Early Grading Permit - Final Drainage Report

Winsome Subdivision Filing No. 3 El Paso County, Colorado

Revise to
EGP-21-005

Inlet Elevation (invert): 7388.00 ft, Outlet Elevation (invert): 7387.80 ft

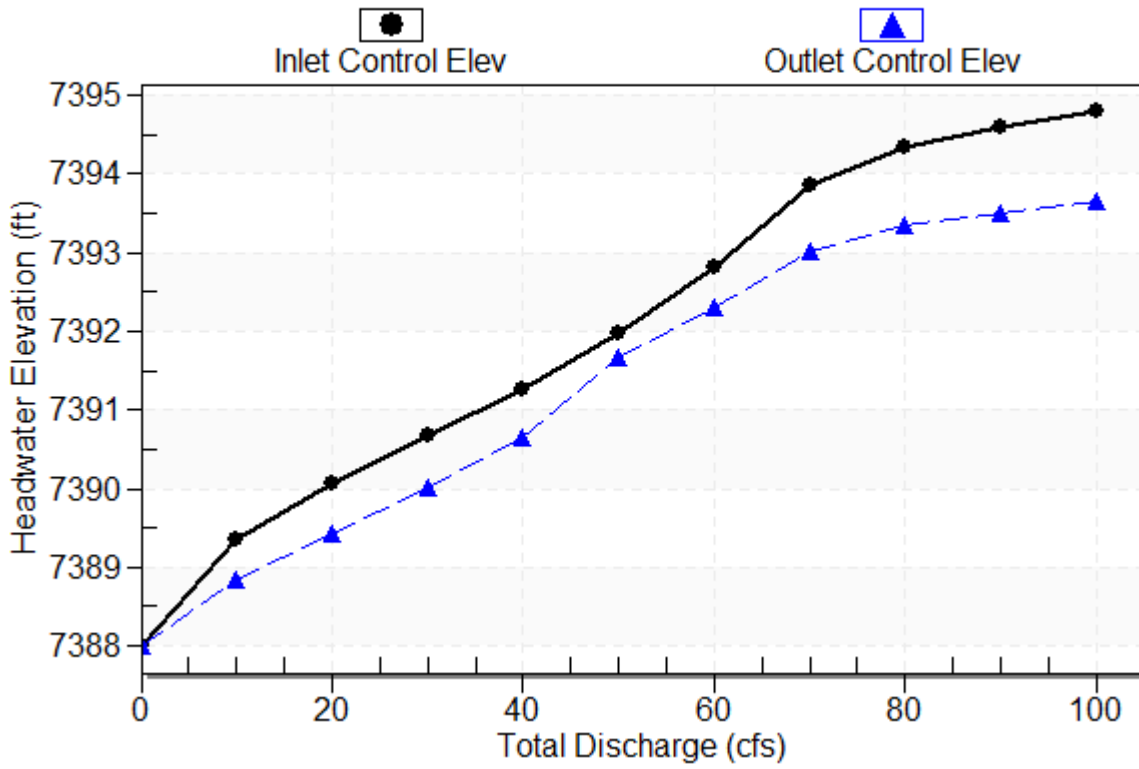
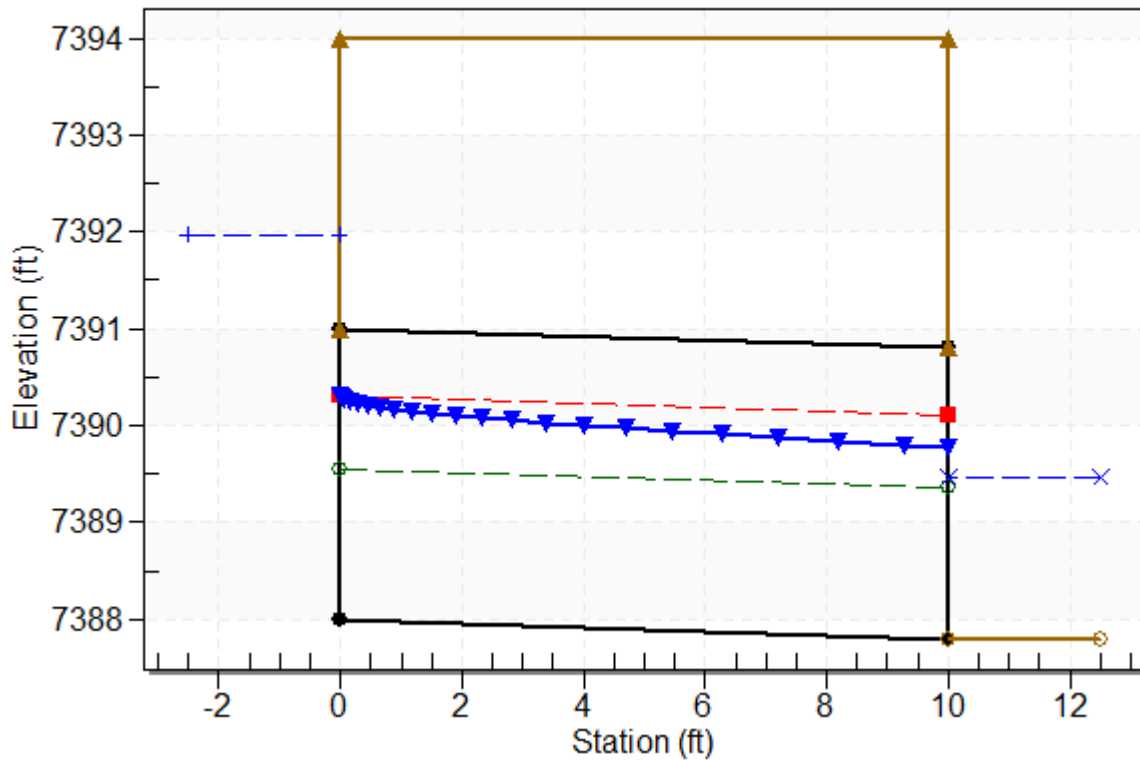
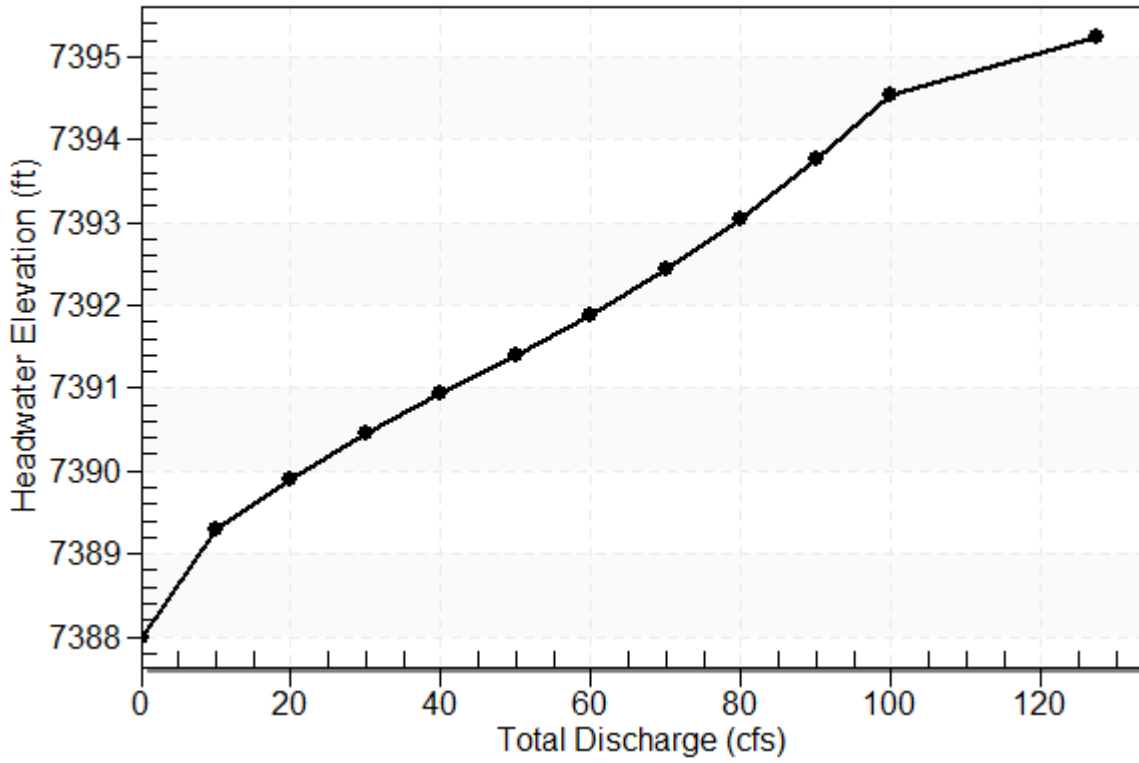
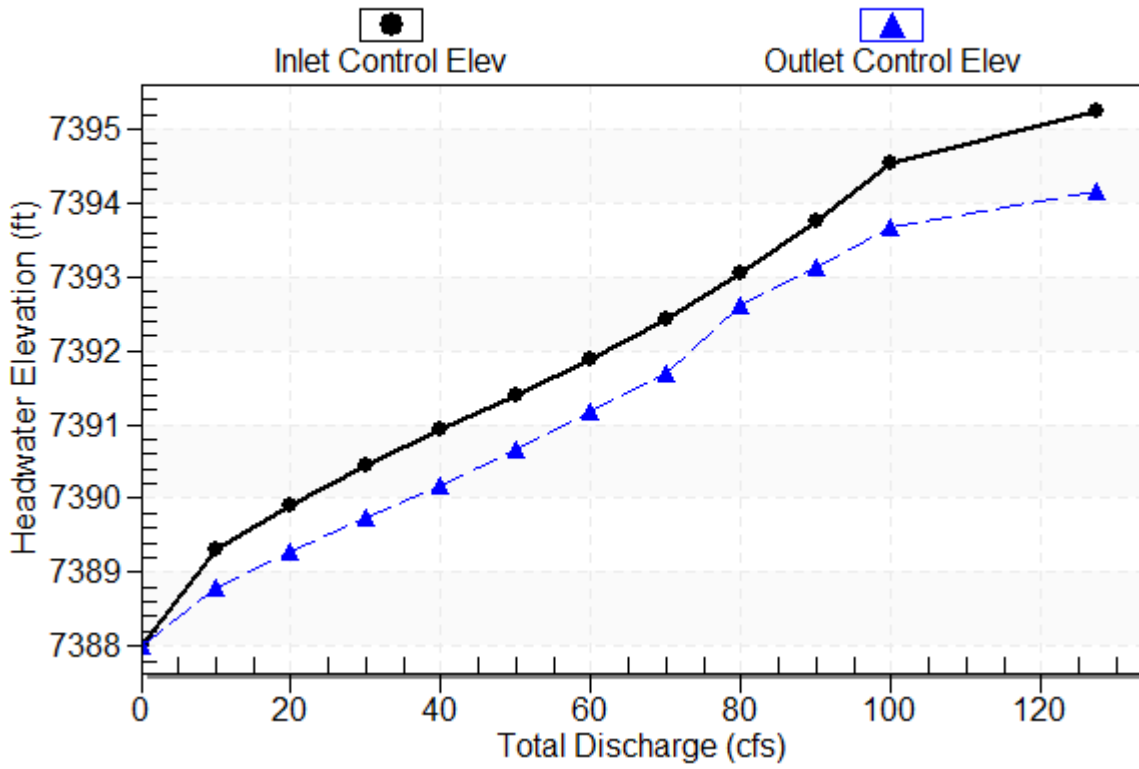
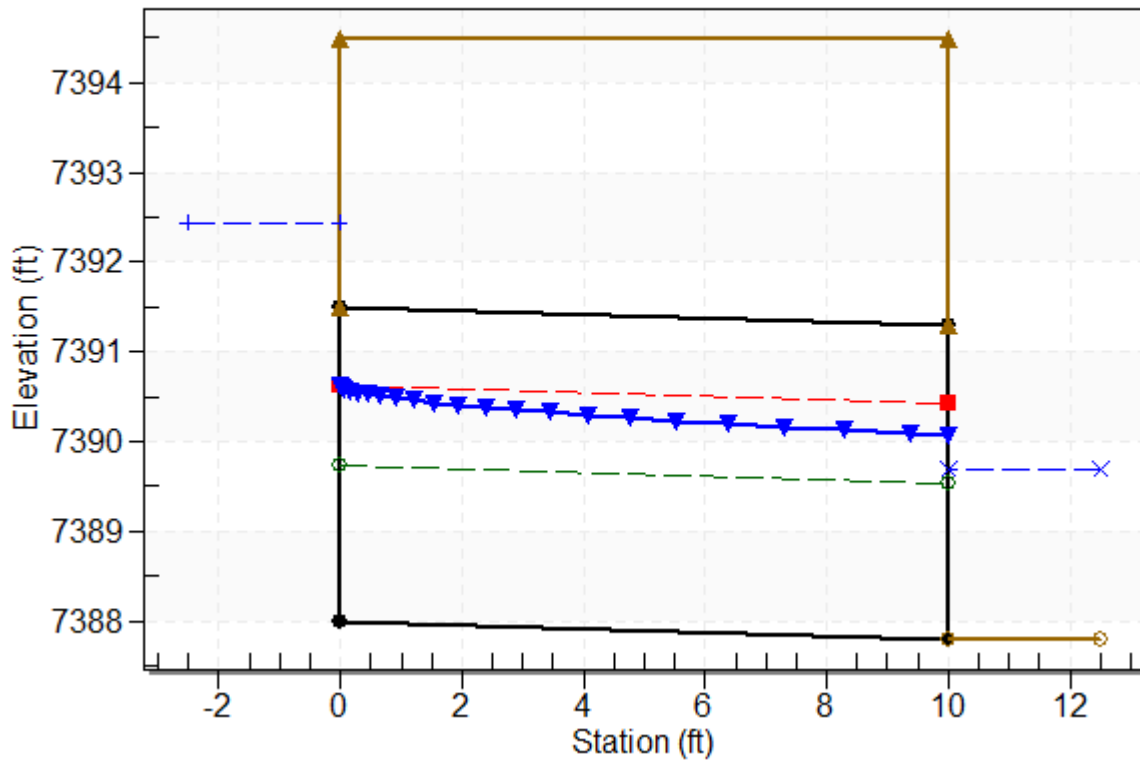
Remove the driveway summary table and supporting culvert analysis from the early grading application (EGP215). This will be reviewed approved with the Final Drainage Report associated with the future final plat application. See comment on page 13.

DETENTION BASIN STAGE-STORAGE TABLE BUILDER

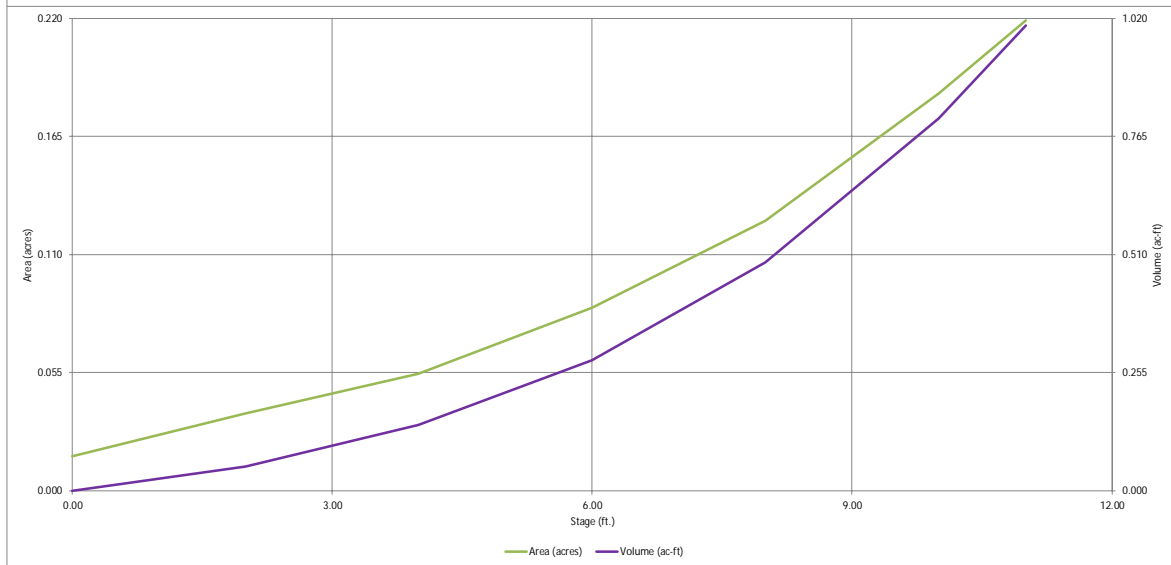
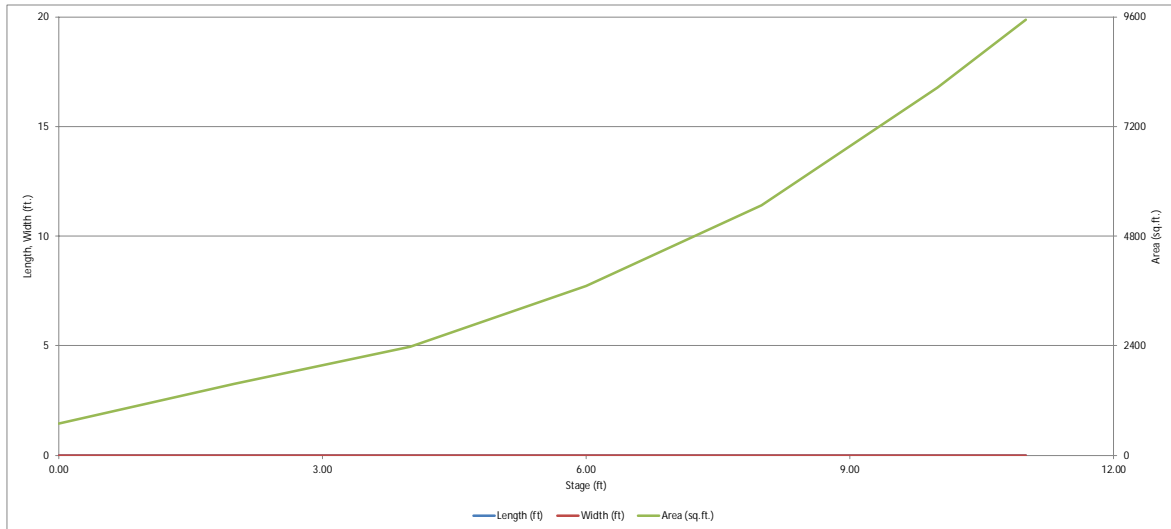
Explain this worksheet in the narrative. The outlet structure does not match & the volume does not match the GEC plans or Temp Sediment Basin Calculation in pg 279 of this report.
